FACILITY: V. C. Summer Nuclear Station

SUBJECT: SUMMARY OF MEETING WITH SOUTH CAROLINA ELECTRIC AND GAS COMPANY

On April 2, 1986, the NRC staff met with the South Carolina Electric and Gas Company (SCE&G) to discuss fire protection for the V. C. Summer Nuclear Station. The meeting was held in Bethesda, MD. A list of those persons who attended the meeting is included as Enclosure 1.

FIRE AREAS/ZONES OF  
INTEREST FOR  
LOSS OF  $T_h/T_c$

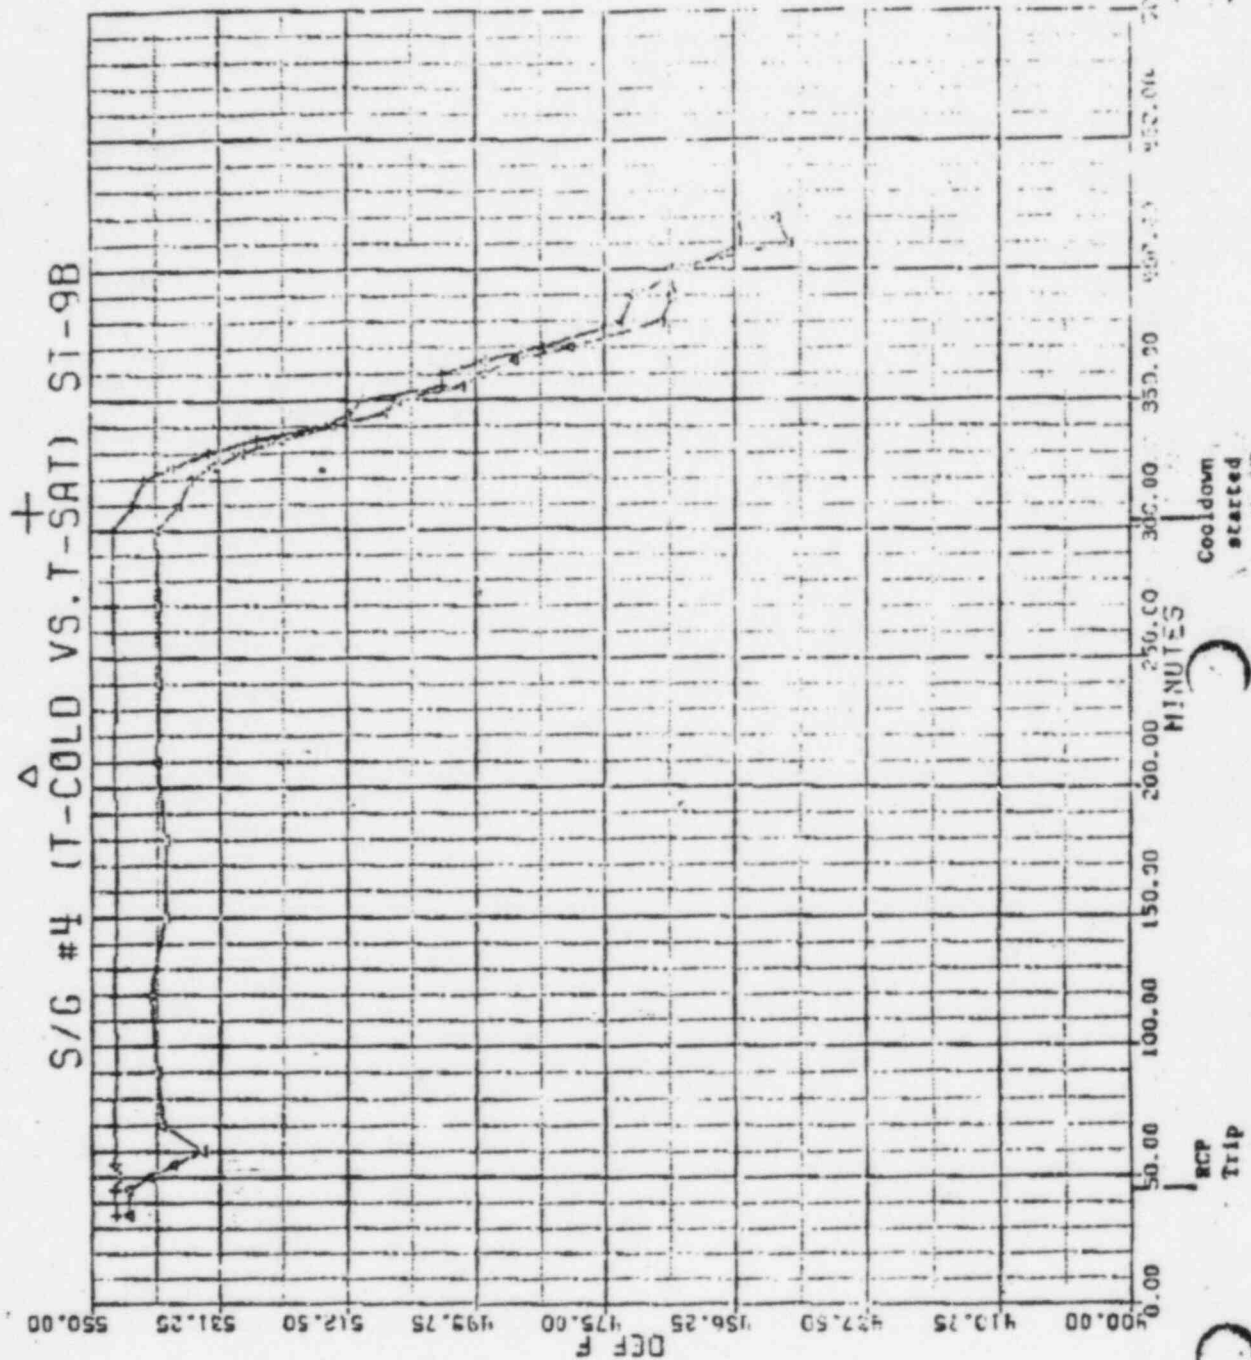
**BASIS FOR GRANTING  
DEVIATION FROM INTERNAL  
GUIDANCE ON  $T_h/T_c$**

1. THE DEVIATION IS REQUIRED FOR ONLY 4 FIRE AREAS/ZONES IN THE PLANT (NONE OF WHICH REQUIRE THE OPERATORS TO LEAVE THE CONTROL ROOM).
2. A WELL REASONED BACKUP METHODOLOGY IS AVAILABLE FOR THESE CASES. ( $P_{sat}$  vs.  $T_{cold}$ ).
3. THE GUIDANCE GIVEN FOR APPENDIX "R" IS NOT CONSISTENT WITH THE WESTINGHOUSE GENERIC AND SUMMER STATION SPECIFIC REQUIREMENTS FOR R.G. 1.97 TYPE 1A or 1B INSTRUMENTATION.
4. THE GUIDANCE GIVEN FOR APPENDIX "R" IS NOT CONSISTENT WITH THE WESTINGHOUSE OWNERS GROUP, EMERGENCY RESPONSE GUIDELINES.

NOTE THAT CONTROL ROOM EVACUATION IS NOT  
REQUIRED FOR ANY OF THESE AREAS. FULL  
 $T_h/T_c$  FOR AT LEAST ONE GENERATOR IS  
AVAILABLE FOR FIRES THAT REQUIRE USE OF  
THE CREP.
